Onondaga County Planning Board

MEETING AGENDA

Wednesday, January 28, 2026
11:00 AM

TAFT ROAD BRANCH CONCEPTUAL SITE PLAN
THE SUMMIT FEDERAL CREDIT UNION

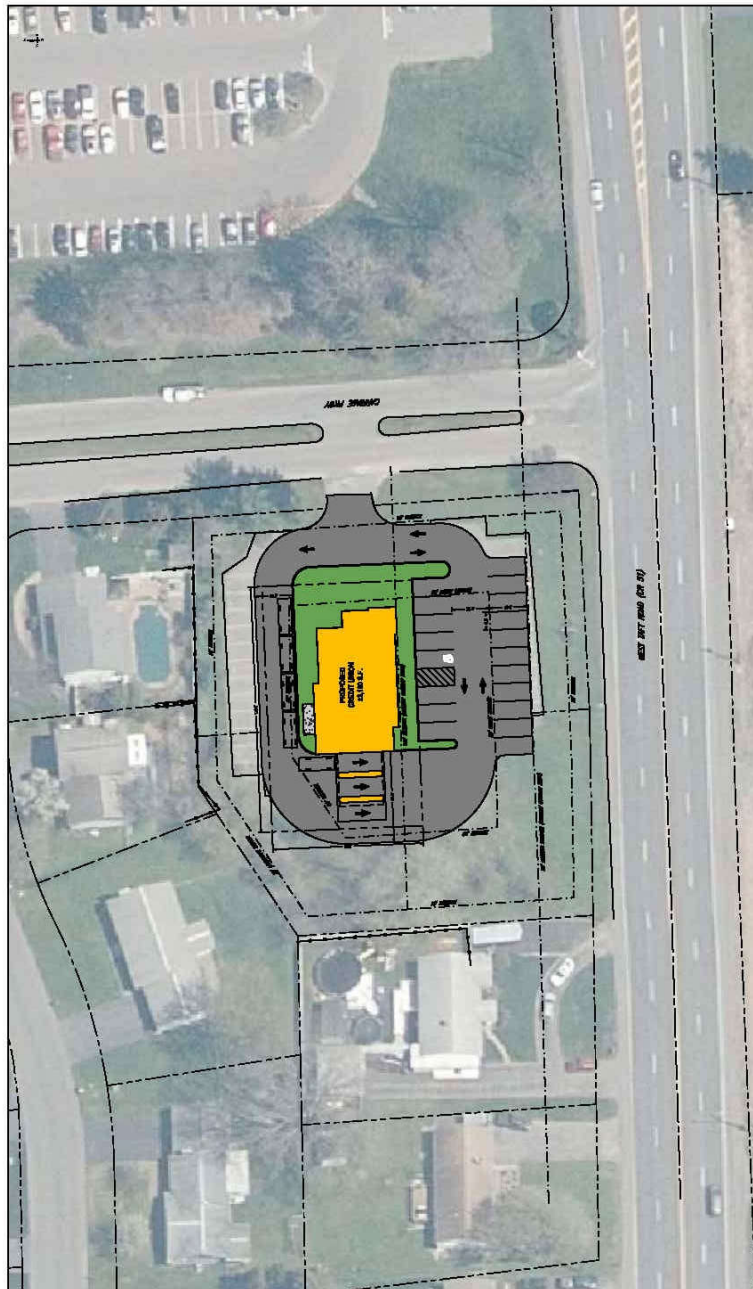
Proposed Site Layout: Per the Taft Road Branch Conceptual Site Plan (undated), the existing building will be demolished to allow construction of the proposed 3,100 sf credit union. The Conceptual Plan depicts the drive-thru queue along the rear of the building and a three-lane drive-thru with bypass lane along the western side of the building. A 19-space parking lot will be located between the building and the West Taft Road frontage.

Landscaping: Per the Taft Road Branch – Concept 2 Plan (undated), it appears landscape screening will be located along the rear and side site boundaries, between the site and adjacent residential parcels. Plant or tree varieties are not specified.

Access: Per the Taft Road Branch Conceptual Site Plan (undated), proposed access to the credit union will utilize the existing site access to Carriage Parkway, a local road.
ADVISORY NOTE: Per the Onondaga County Department of Transportation, additional access to West Taft Road will be permitted.

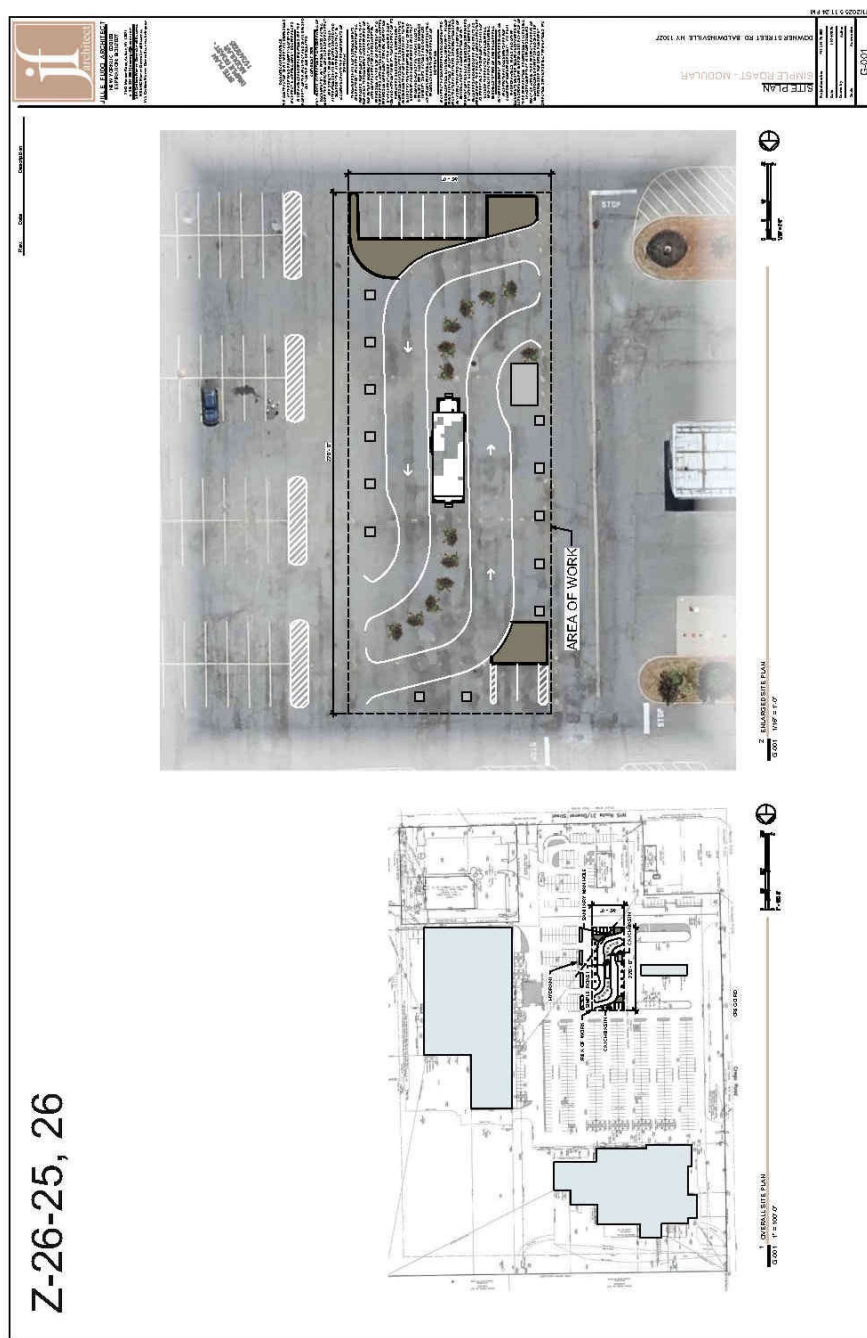
Per the Site Plan dated 11/24/25, the building will have a single drive-thru lane on either side of the hut with possible landscaping extending from the building to the drive-thru lanes. A dumpster enclosure will be constructed and 7 parking spaces will be striped for employees. The proposal will result in a decrease of total parking spaces within the plaza parking lot.

Note, the Site Plan lacks clarifying details and labeling. It is unclear if there will be curbing installed, if dark gray areas depicted on the plan will be landscaped with a different surface, or will be outlined by striping.

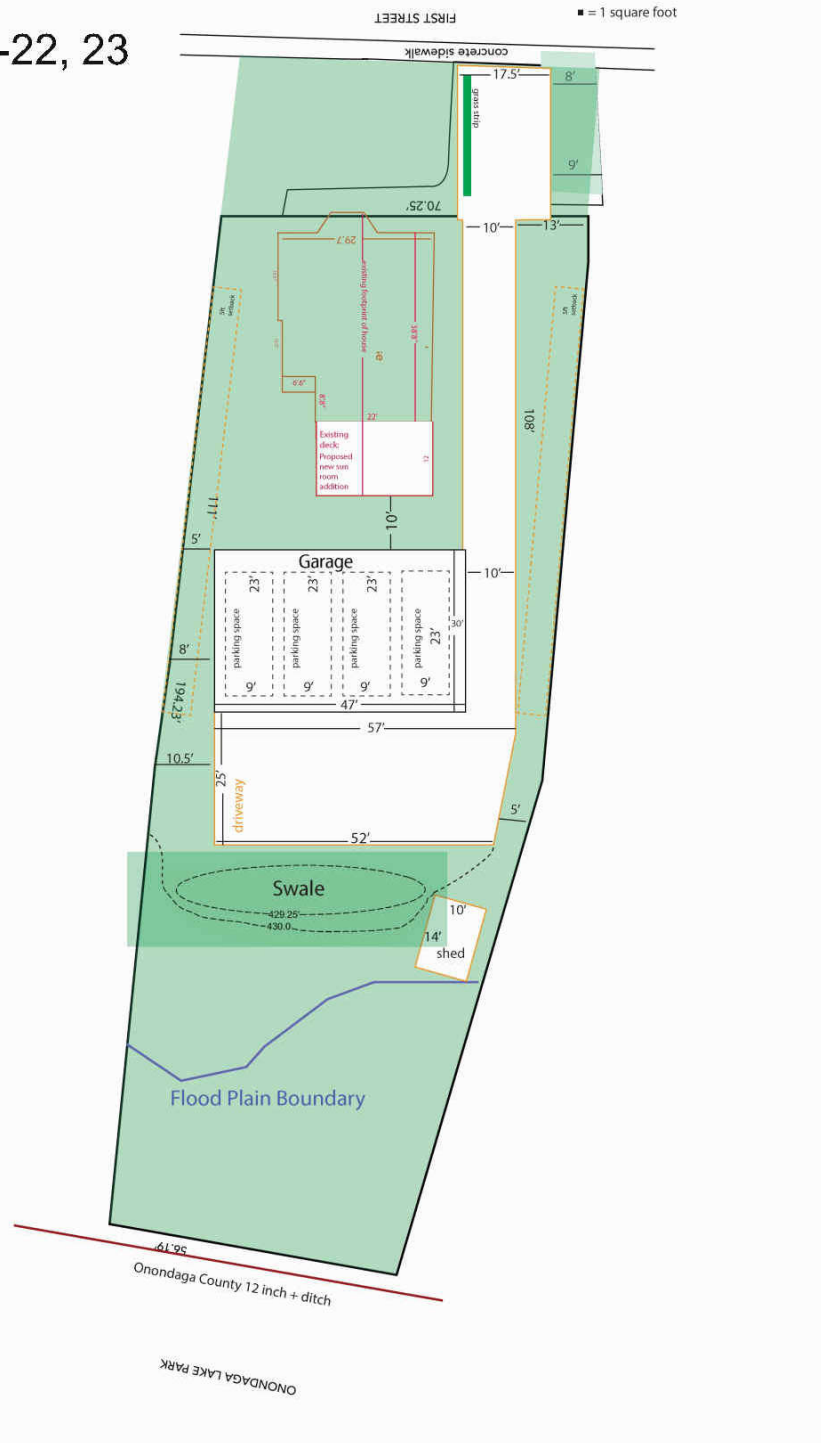
Proposed Site Layout: Per an untitled, undated Site Plan, the applicant will narrow the existing driv access from First Street and will install an 8-9'-wide landscaped strip betwe driveway and the adjacent parcel's driveway. A "grass strip" is shown on the the driveway, possibly indicating separation between the driveway and a sidewalk leading to the house, but this detail is unclear.

The driveway will narrow to 10'-wide the remaining length of the driveway to 25'x52'x57' parking area that will provide access to a new one-story, four-car garage. Vehicle-access to the garage will come from the lake-facing side of garage. Construction material of the driveway is unclear. Per Village Planni Board minutes from 10/27/25, the proposed driveway has been approved.

Stormwater: Per the Environmental Assessment Form (EAF) dated 1/1/2026, 0.03 acres site will be disturbed by the proposed project. The Site Plan depicts a swale constructed to the rear of the parking area. A 10'x14' shed is shown adjacent to the swale. The shed is not present in aerial photography and is not detailed in the project descriptions.
